## **Access Compliance Report Public Rights-of-Way** (Curb Ramps)

Main Street: CHAPMAN AVE **Cross Street: BEACH BLVD** Location:

ADA ID: RPRK210928152105 Ramp Type:Type 1 - Perpendicular Diagonal Initial Pass/Fail: Fail **Overall Compliance: No Severity Score:**

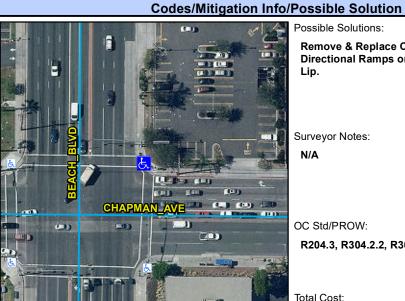
Field Measurements/Component Compliance								
	Compliance Description			ta Compliance Description				
	N/A	Ramp Length (in)	90	N/A	Flare Type LT			
	Yes	Ramp Width (in)	48			N/A		
	No	Ramp Run Slope (%)	14.1	N/A	Flare Slope LT (%)	N/A		
	No	Ramp Cross Slope (%)	3.5	N/A	Flare Traversable LT	N/A		
	N/A	Landing Present	N/A	N/A	Flare Type RT			
	N/A	Landing Length (in)	N/A			N/A		
	N/A	Landing Width (in)	N/A	N/A	Flare Slope RT (%)	N/A		
	N/A	Landing Run Slope (%)	N/A	N/A	Flare Traversable RT	N/A		
	N/A	Landing Cross Slope (%)	N/A	N/A	DWS Provided	N/A		
	N/A	Landing Movement Obstructed?	N/A	N/A	DWS Contrast	N/A		
		Landing Movement Type	N/A	N/A	DWS Length (in)	N/A		
	N/A	Landing Shared	N/A	N/A	DWS Full Width	N/A		
	N/A	Clear Space	Yes	N/A	DWS Offset Left (in)	N/A		
	N/A	Clear Space To Crosswalk (in)	48	N/A	DWS Offset Right (in)	N/A		
0	N/A	Marked Crosswalk 1	Yes	N/A	Marked Crosswalk 2	Yes		
		Crossing 1 Direction	NW		Crossing 2 Direction	SW

Е		Marked Crosswalk 1 Width (in)	122		Marked Crosswalk 2 Width (in)	122		
al	N/A	Ramp Inside Crosswalk 1	Yes	Yes	Ramp Inside Crosswalk 2	Yes		
D		Crossing 1 Slope (%)	6		Crossing 2 Slope (%)	3.2		
al		Crossing 1 Cross Slope (%)	2.3		Crossing 2 Cross Slope (%)	3.3		
	N/A	Gutter Ponding	N/A	N/A	Curb Slope	3.1		
	No	Gutter Lip Height (in)	0.25		Road Run Slope (%)	2.5		
	N/A	Gutter Run Slope (%)	N/A		Road Cross Slope (%)	1.9		
a	N/A	Gutter Cross Slope (%)	N/A					
S	Yes	Overall Surface Condition: Accep	otable	No	Perp Joint Present	No		
		Cross Gutter Present?	No		Spandrel Present?	No		
X		Replace Cross Gutter?	N/A	l	Replace Spandrel?	N/A

Remove & Replace Curb Ramp With Two New **Directional Ramps or Equivalent. Grind Gutter**

R204.3, R304.2.2, R304.5.3, R302.7.2, STD 1115
